CIELO COLORADO ESTATES

Re: CDRC Case MP 12-5450 Cielo Colorado Master Plan

The Cielo Colorado Master Plan proposal, for a Type II subdivision consisting of 67 lots on 257.16 acres, was assessed for technical accuracy and code compliance aspects with regards to terrain management. The information contained in the report was consistent with the physical attributes of the property. The proposed building envelopes, drainage and storm water retention sites are adequate for this proposal.

RE: CDRC Case # Z/S 12-5450 Cielo Colorado Master Plan – T15N R10E Projected Sections 20, 21 & 22

OBA -79

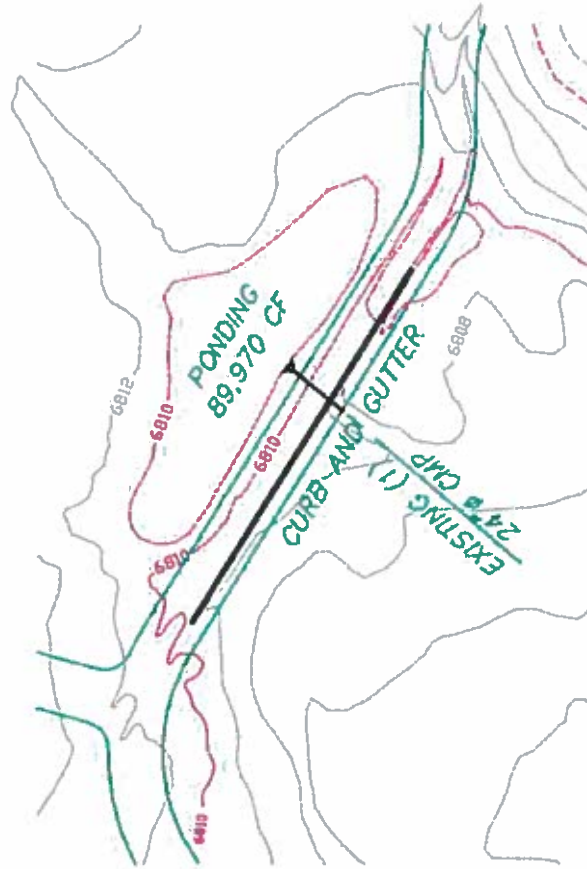
EXISTING CURB IS 6" IN HEIGHT
 A CUT ON THE CURB ALLOWS
 WATER ON ROAD TO DRAIN.

CHANNEL SLOPE = 1.57%
 VELOCITY = 5 FT./SEC.
 CURB LENGTH = 300 FT
 PEAK FLOW = $Q_p = 269.42$ CFS

DETERMINE DEPTH OVER CURB
 $A = Q/V$
 $300 \times d = 269.42 / 5$
 $d = 269.42 / 5 \times 300 = 0.18$ FT
 OR 2" ABOVE CURB

CONCLUSION:
 DURING PEAK FLOW THE ROAD
 WILL HAVE 8" WATER DEPTH
 IN A DURATION OF 15 MIN. OR
 LESS. THAN 6" DEPTH DRAINS THRU
 CURB CUT. WATER ON ROAD WILL
 TAKE 45 MIN. TO EMPTY

OBA - 8C

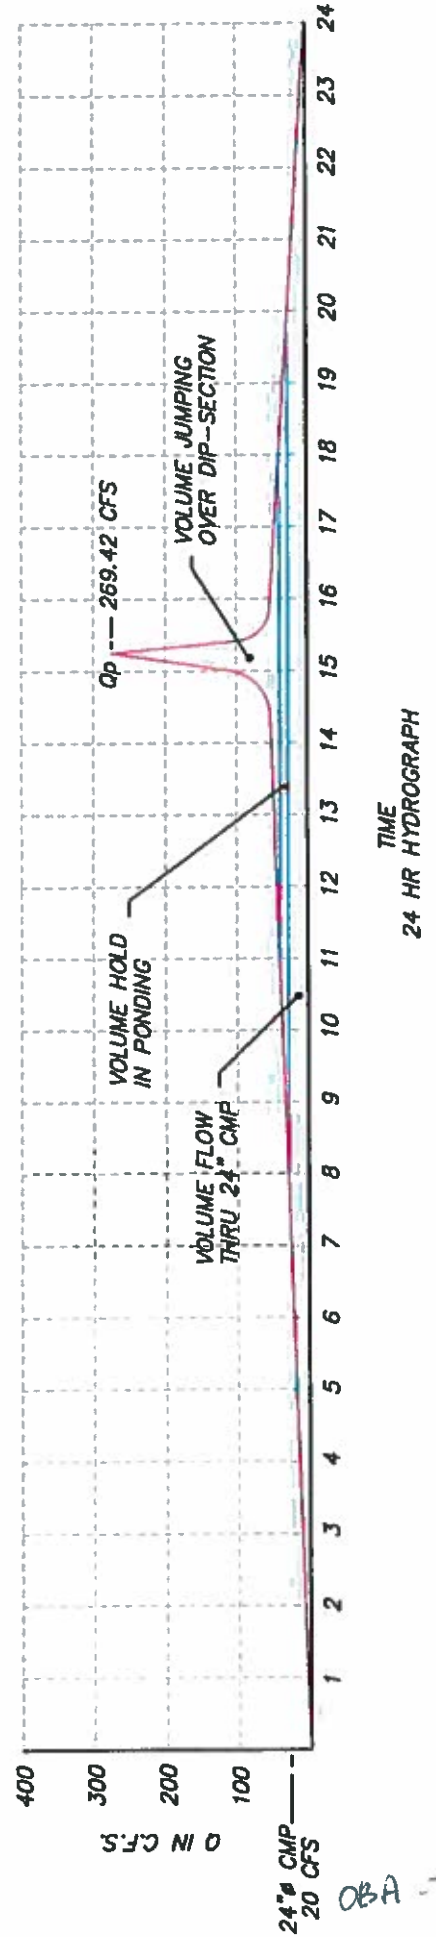
POND WILL DRAIN THRU 24" PIPE
 IN 90 MINUTES.

Proposed 2013 Master Plan (detail)

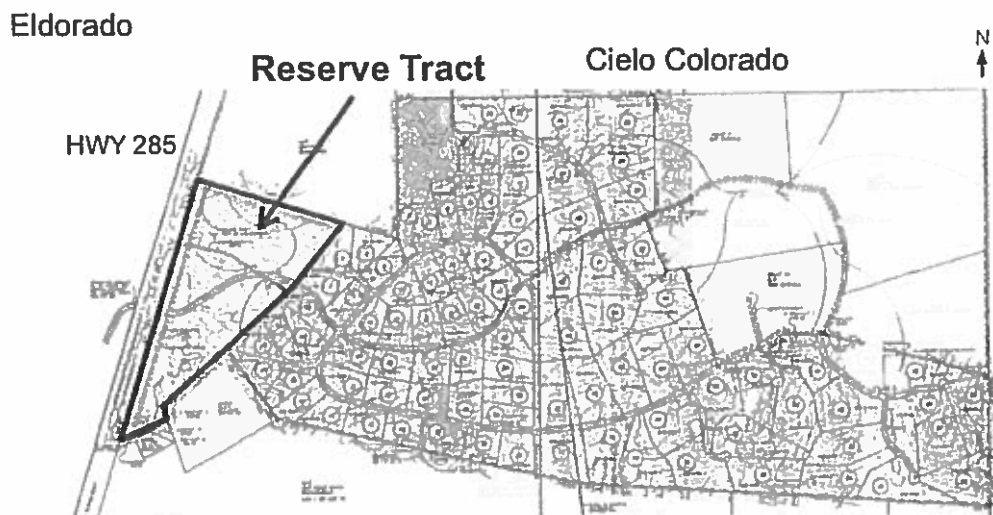
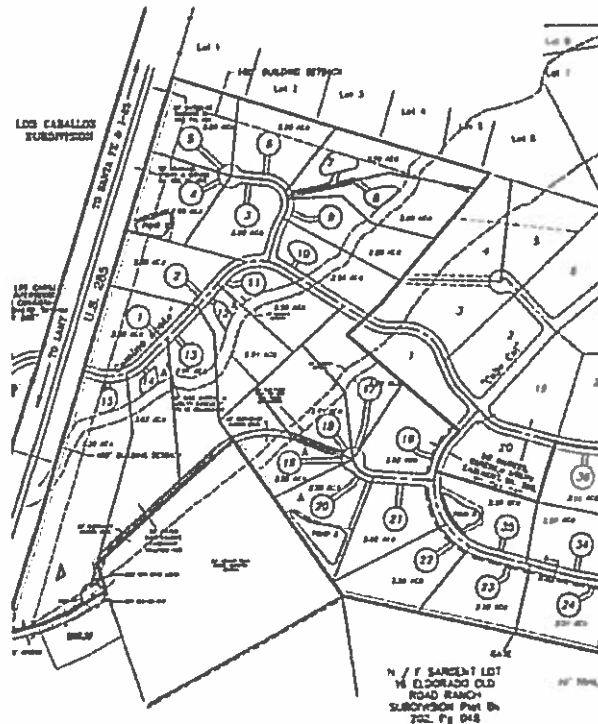
The new 2013 Master Plan populates the Reserve Tract with 15 lots:

1. Ordinance (2005-8 sec 8.8.A.1) requires 100' setbacks, but the US 285 South Highway Corridor Plan (Resolution 2004-73, July 2004, p. 87) recommends at least 160' and preferably 200' noise set-backs;
